SERVICE BULLETIN

PURPOSE : CHANGE	ISSUE NO. : MSB-15E42-004	DATE : 2015-06-25
SUBJECT : Omission of the silencer application locations		<DESTINATION/MODEL> (EU/RUSSIA) <M/Y> 16
GROUP : Gr:42(Body)		OUTLANDER(GF0W)/ OUTLANDER PHEV(GG0W)

SILENCER APPLICATION LOCATIONS

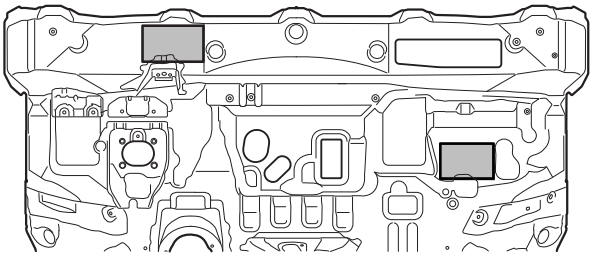
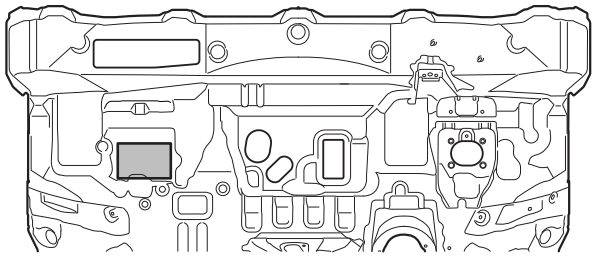
<Added>

An additional silencer (spray-type anti-vibration agent) is applied as shown, thus suppressing vibration and noise.

<LH Drive vehicles>

<RH Drive vehicles>

NOTE:
: 2.5 mm film thick spray-type anti-vibration agent. (Place two 1.6 mm melting sheet one on top of another.)
